Dealer Service Bulletin

NO.: 7SB001-02-01A

AFFECTED: 1995-2000 Rialta motor homes

SUBJECT: VW Eurovan Chassis Oil Filter Access Improvement

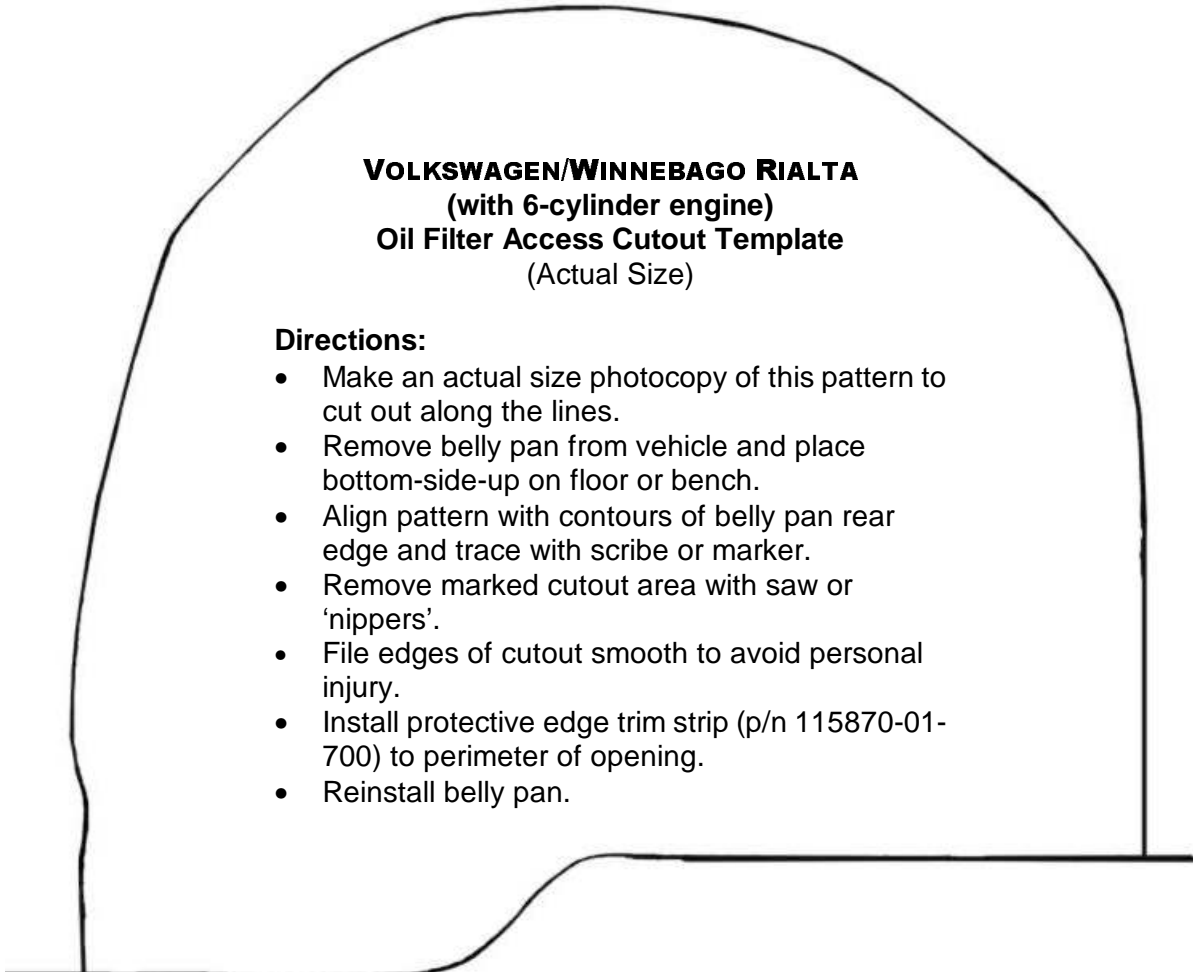
FOR 5-CYLINDER ENGINE VEHICLES:

Modify Belly Pan Attachment Hangers

The belly pan attachment hinges (hangers) may be modified by bending as shown. This modification allows removal of the swing-down type belly pan by simply jacking the front end slightly, without having to raise the vehicle on a hoist.

- Remove belly pan from vehicle and place bottom-side-down on floor or bench.
- Use pliers or other gripping tool to change the angle of both attachment hangers to 45° as shown on template at end of bulletin.
- Reinstall belly pan.
